Memorandum to the City of Markham Committee of Adjustment

File: A/057/25
Address: 4611 Highway 7 East, Markham
Agent/Applicant: Glen Schnarr & Associates Inc.
Hearing Date: Wednesday, November 26, 2025

The Applicant is proposing to restore and expand the existing building to construct a 1,366.06 m² (14,704.15 ft²) two-storey automobile dealership (the “Proposed Development”) (refer to Appendix “B” – Plans).

1 SITE PLAN
SCALE: 1:200

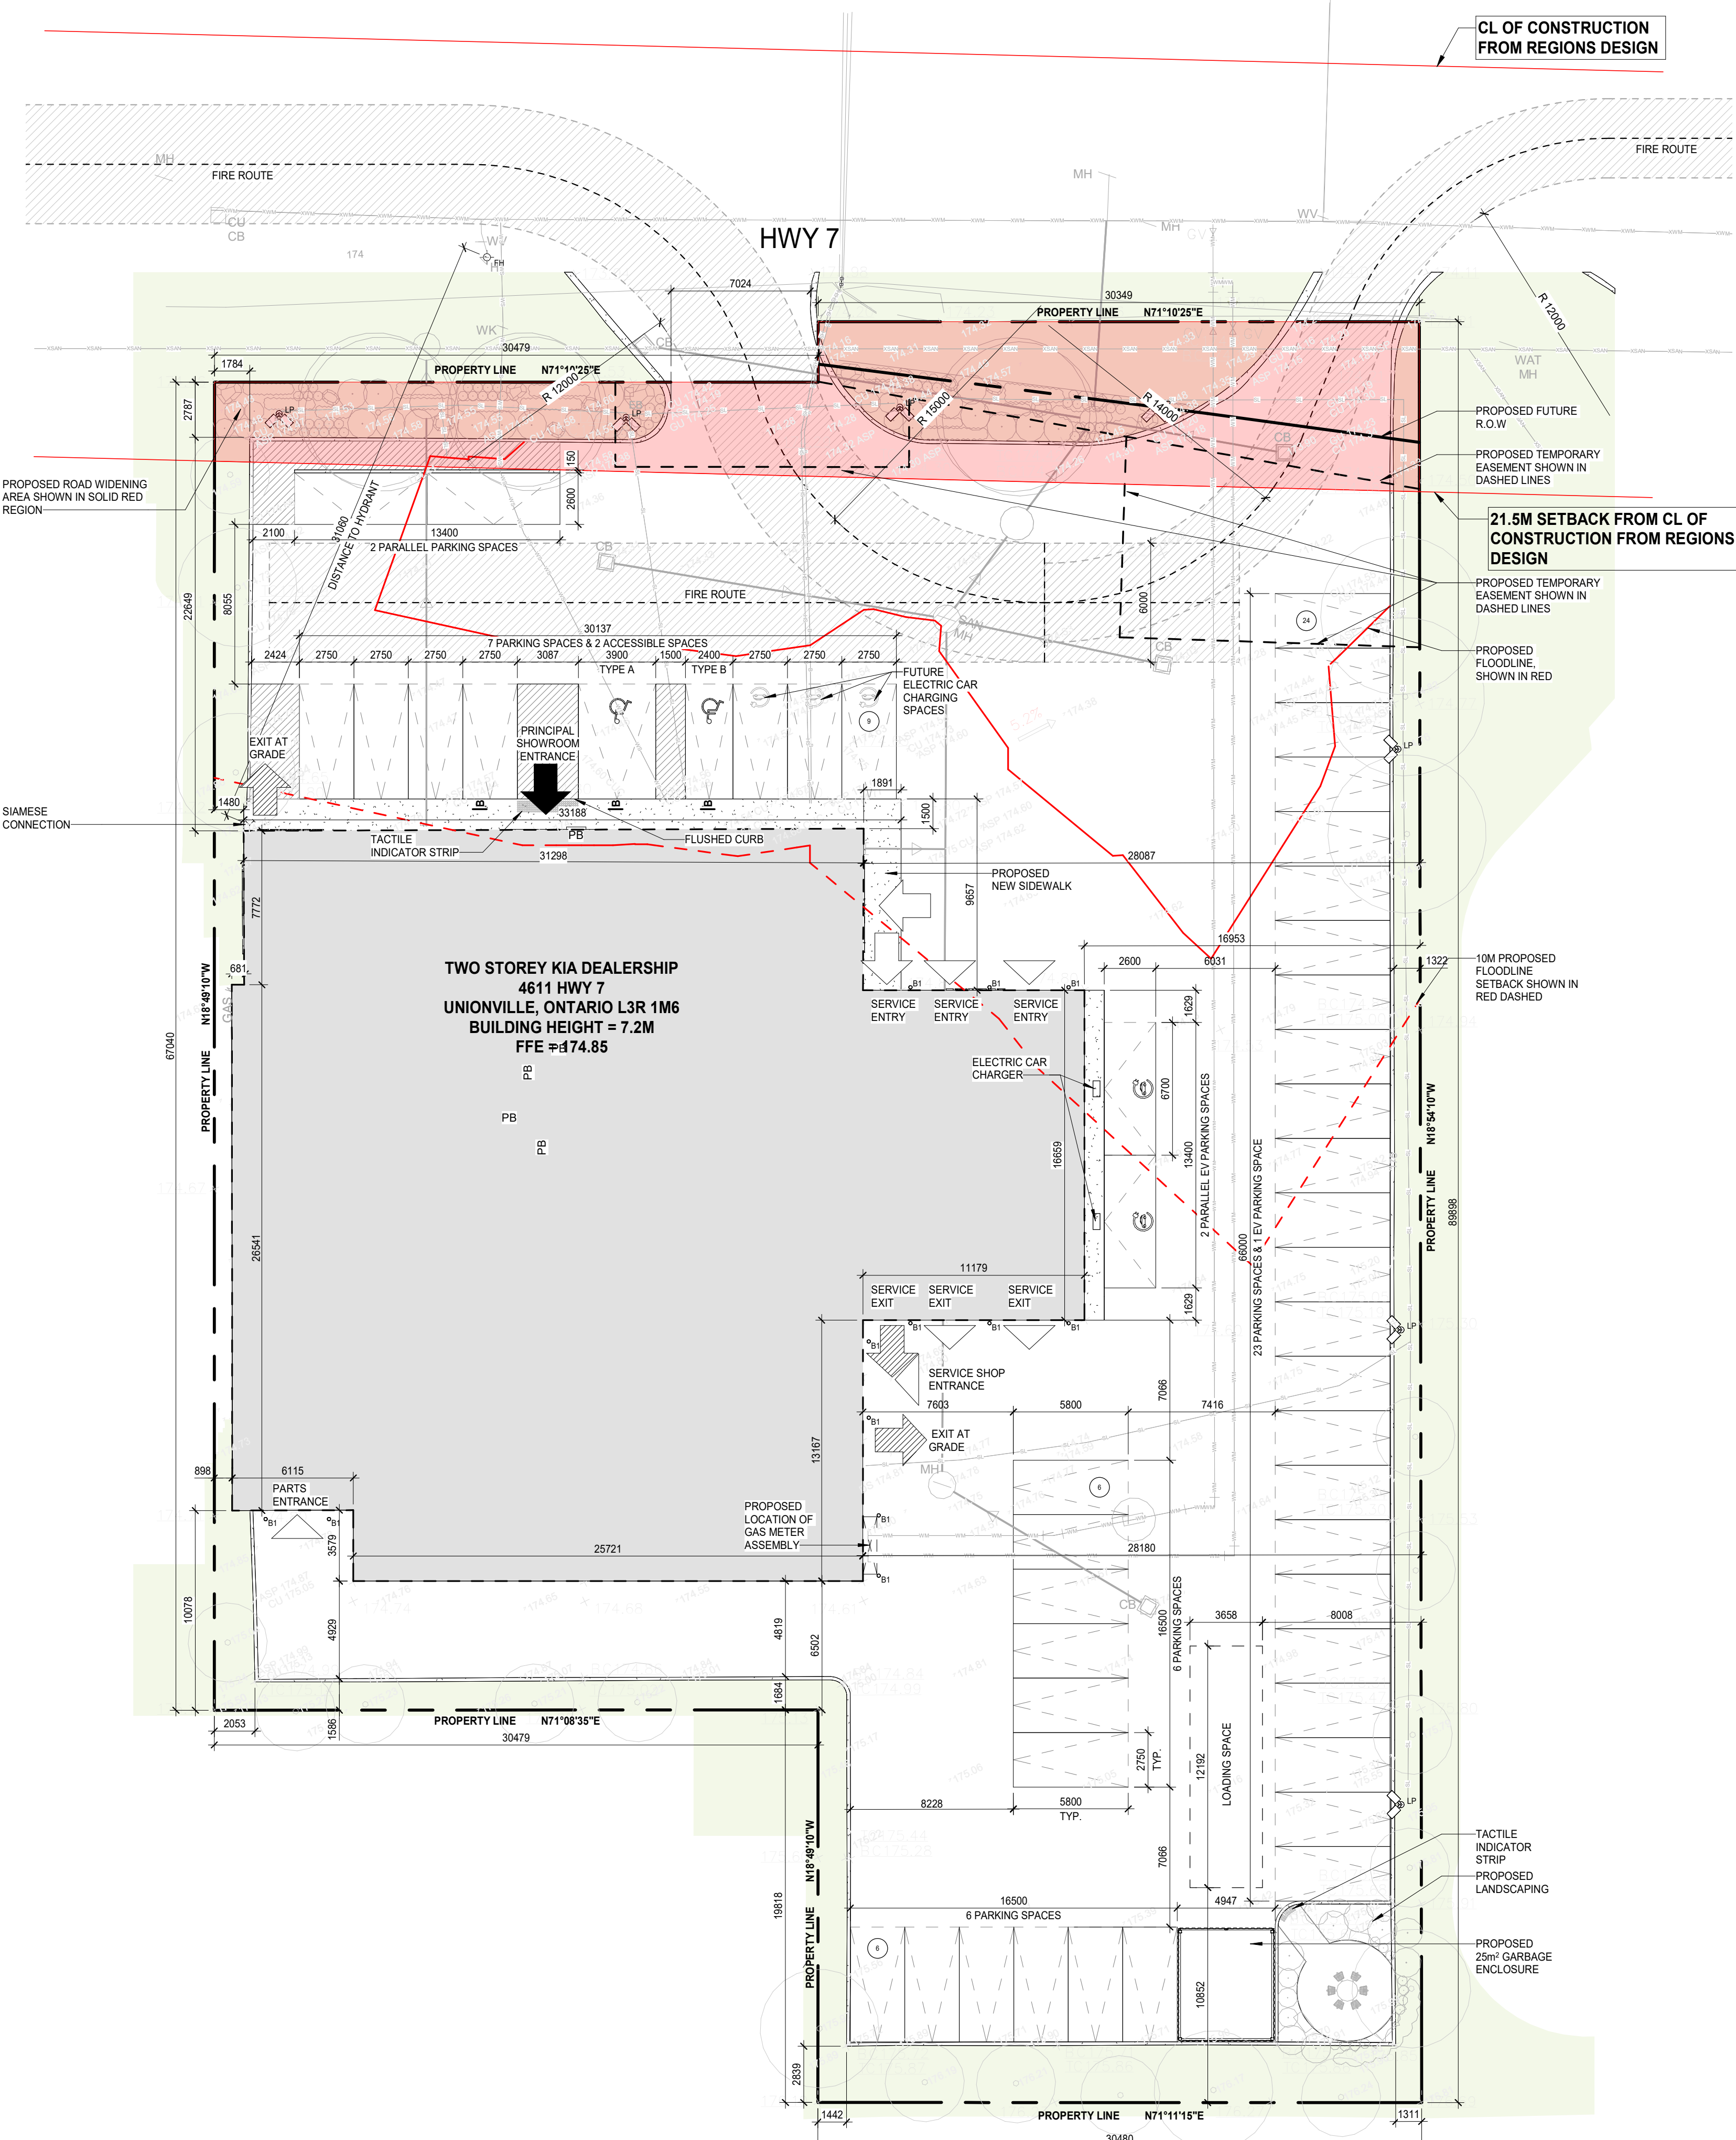
Staff note that requested variance is an existing condition to the parking layout that is currently on the Subject Lands. Transportation Engineering has reviewed the application and have no objection to the proposed variance, provided the Applicant remove parking spaces near the terminus of the parking aisle to improve maneuverability. The Applicant has accommodated the request in their updated plan which will be reviewed in more detail as part of the Site Plan review process.

#	TRCA Comments
1	Although TRCA staff have no concerns with the proposed variances, staff ask that the future electric car charging spaces be relocated outside of the Regulatory Flood Plain and its associated 10-metre setback.
2	The applicant submits the TRCA plan review fee of \$1,250 within 60 days of the committee hearing date.
3	The applicant seeks and is issued a permit by TRCA pursuant to the <u>Conservation Authorities Act</u> .
